# AGENDA MEMORANDUM

Title:Site Development Plan (SDP), Facade Approval

Subject Property: 407 N. Wilcox Street

Proposed Façade Improvements Project # SDP19-0024

Existing Views from Wilcox Street

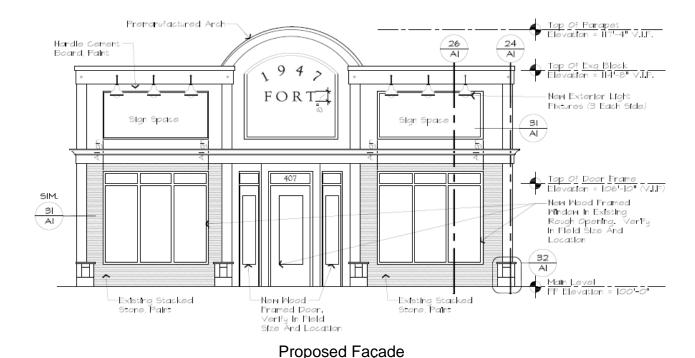
applicant proposes to remove the existing cap flashing, mansard roof, and wood façade from the Wilcox Street, front and alley, side facades.

Cap Flashing, Mansard Roof, and Wood to be Removed, Highlighted Above

The existing windows and doors would also be removed, but the openings would remain with new wood framed doors and windows added in the same locations. Also proposed is a premanufactured arch to the top center of the parapet, new Hardie cement board on either side of the arch that would also accommodate signage, new exterior lighting, new wood framed windows and doors, and painting the existing stacked stone. One of the new wood framed windows would resemble a faux door since it is in center of the façade. The proposed design blends with the historic character of the downtown.
